**Vogtle Electric Generating Plant
License Renewal – Revised RAI Responses**

**Vogtle Electric Generating Plant
License Renewal – Revised RAI Responses**

Revised Responses to RAIs 2.3.3.19-1, 3.3-1 & 3.4-1, and 4.3-04

Figure 1: Design Transient for Fast Transient

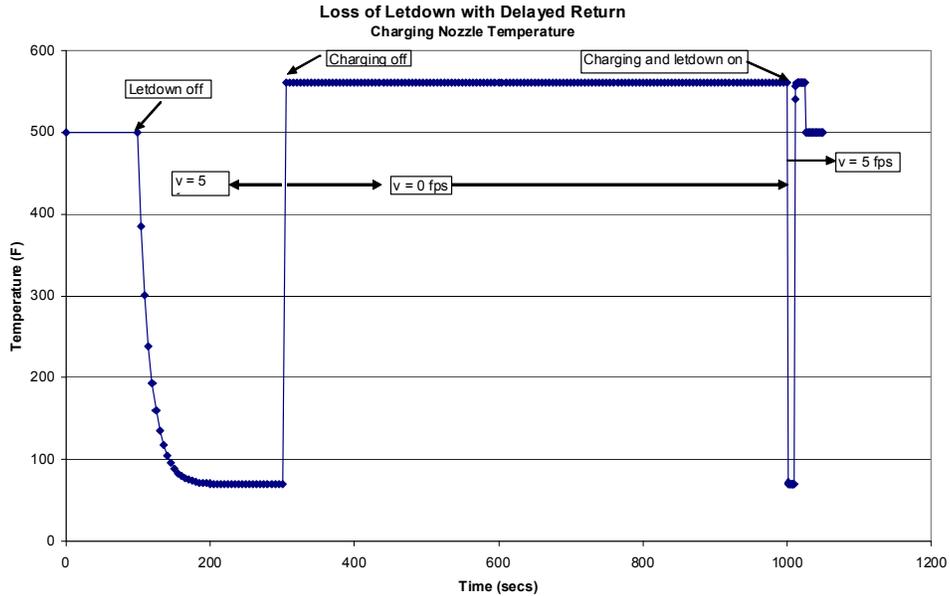
- a. Figure 1 and Figure 2, the temperature transient curves for the charging nozzle, are missing from the response. Please provide them.
- b. The locations for the charging nozzle and the surge line hot leg nozzle are at the safe-end region. Confirm the critical fatigue locations are at the safe-end region and provide supporting analysis results.

- a. When the attachment to NL-08-0228 was converted to pdf format, the page with Figures 1 and 2 was inadvertently left out. They are included below.
